Application for Licence Amendment

Licence Number	L9240/2020/1
Licence Holder	Tellus Holdings Ltd
ACN	138 119 829
File Number	DER2020/000039
Premises	<p>Sandy Ridge Facility</p> <p>Crown lease O289974 granted by the State of Western Australia to Tellus Holdings Ltd in respect of Lot 510 on Deposited Plan 413497, Whole Volume 3169 Folio 365.</p> <p>102.5km north of Great Eastern Highway, via Access Reserve 44102, BOORABBIN WA 6429.</p> <p>As defined by the coordinates in Schedule 2 of the Revised Licence</p> <p>As defined by the Premises maps attached to the Revised Licence</p>
Date of Report	19 March 2021
Decision	Revised licence granted

Figure 1: Excavated waste cell and inferred depth to unweathered granite bedrock

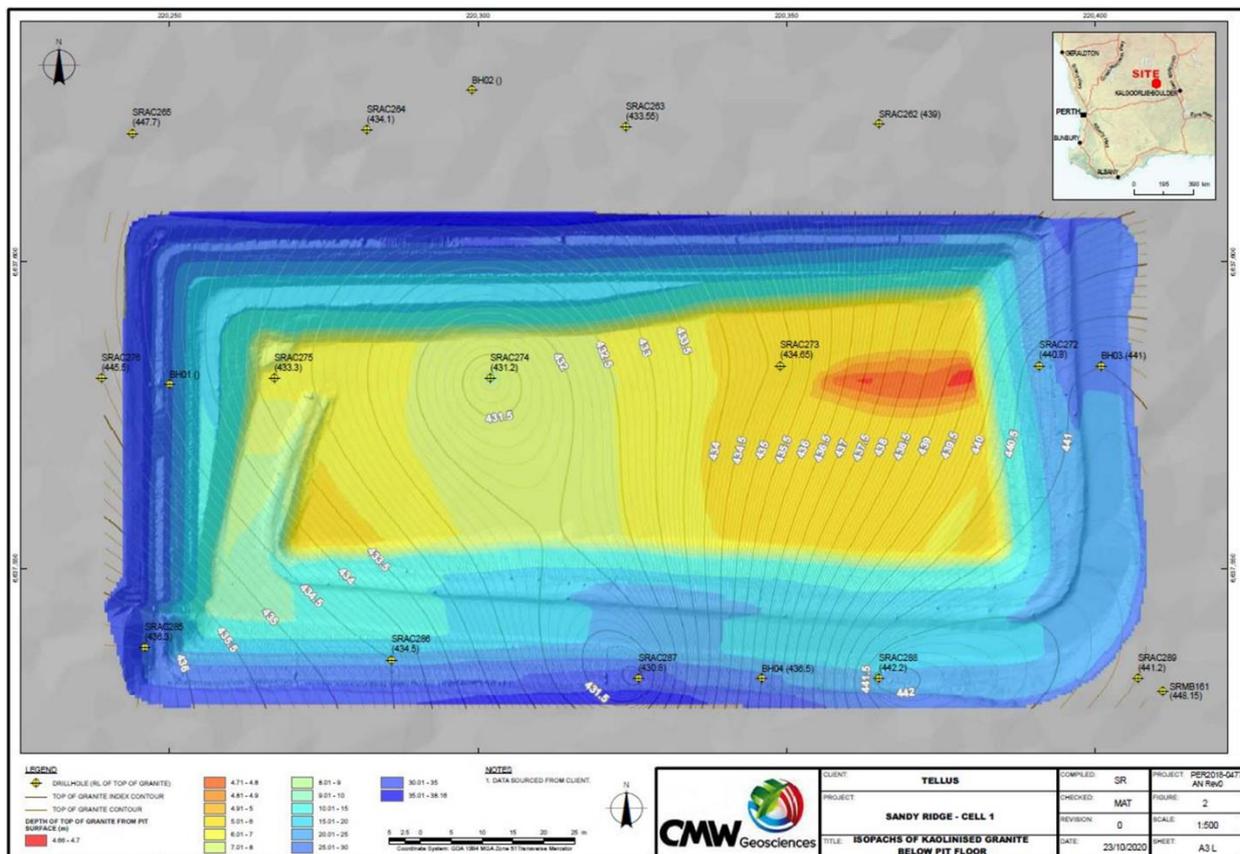
Variations were noted in the waste cells where certain areas within the constructed waste cell were inferred to be 4.7m of the underlying unweathered granite rock and not the minimum 5m specified within Works Approval W6308/2019/1.

The CCR detailed, an area of approximately 213m² (5% of the total pit floor) is interpreted to have a thickness of between 4.7m and 5m above the unweathered granite. The Works Approval Holder (via Geotechnical consultants CMW Geosciences) determined the inferred cell floor height (above the unweathered granite) utilising a model that incorporated data from exploration boreholes and geotechnical boreholes from within the cell footprint area. The kriging method of interpretation was then applied to interpolate the unweathered granite surface below the cell floor. This interpolation indicated that the area of kaolinised granite less than 5m in thickness (marked by orange to red tones in Figure 1 below) is situated in the north eastern corner of the waste cell. It is this area that is outside the minimum 5m specification of the Works Approval (Table 2, Condition 1).

The specified 5m thickness of the kaolinized granite was specified by the Works Approval Holder in the application for Works Approval W6308/2019/1. The variation in depth to the unweathered granite was also part of the proposal assessed under MS1078. The variation in depth was referred to DWER Environmental Compliance, and advice received indicated that this variation was not a considered material issue.

The Delegated Officer reviewed the CCR and advice from the Part IV and V Environmental Compliance teams and noted:

- The variation in depth to unweathered granite is acknowledged to only impact a small portion of the constructed waste cell.
- The variation has been identified via an inferred assessment method (based on available adjacent borehole details).
- A qualified geotechnical engineer has certified the variation as minor in nature and is not considered to increase the risk to public health or the environment.
- The variation in minimum cell depth for waste cell 1 is not considered a material variation.

The Works Approval Holder (via the geotechnical consultant CWM Geosciences) detail that:

- the design intent of the 5m cover requirement was to create a separation between any perched potential groundwater that might accumulate in the future on the fresh granite surface and the floor of the cell.
- A trough in the fresh granite surface runs in a north-south direction beneath the centre of the cell. It is in this area where perched groundwater, if it were to occur, would most likely accumulate.

- In this area the depth of cover is more than the required 5m (7 to 8m). For this reason, the localised and minor departure in the depth to the unweathered granite bedrock noted above does not increase the risk to public health, public amenity or the environment and the original design intent is achieved.

Based on the above, the Works Approval Holder considered that the variation in waste cell floor separation to the unweathered granite is captured by Works Approval condition 2.
